Product Change Notification / KSRA-13AKNI696

CCB 4440 and 4440.001 Initial Notice: Qualification of MMT as an additional assembly site for selected MITCH112. MITCH180, PIC10xxxx and PIC12xxxx products available in 8L DFN (3x3x0.9mm and 2x3x0.9mm) package.

**CCB 4440 and 4440.001
Pre and Post Change Summary
PCN #: KSRA-13AKNI696**

Pre and Post Change

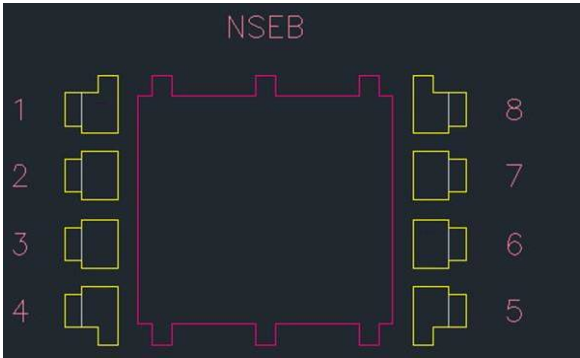
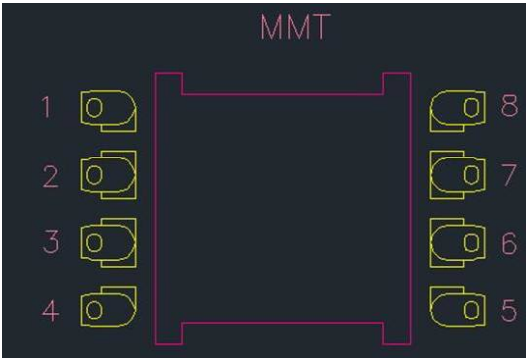
Pre Change	Post Change
Lead frame Design	 <p>The diagram shows a central rectangular area labeled "NSEB" in pink. It is surrounded by eight lead frames, numbered 1 through 8 in pink. Leads 1-4 are on the left, and leads 5-8 are on the right. Each lead frame is outlined in yellow and has a small rectangular tab extending outwards.</p>	 <p>The diagram shows a central rectangular area labeled "MMT" in pink. It is surrounded by eight lead frames, numbered 1 through 8 in pink. Leads 1-4 are on the left, and leads 5-8 are on the right. Each lead frame is outlined in yellow and has a circular tab extending outwards.</p>
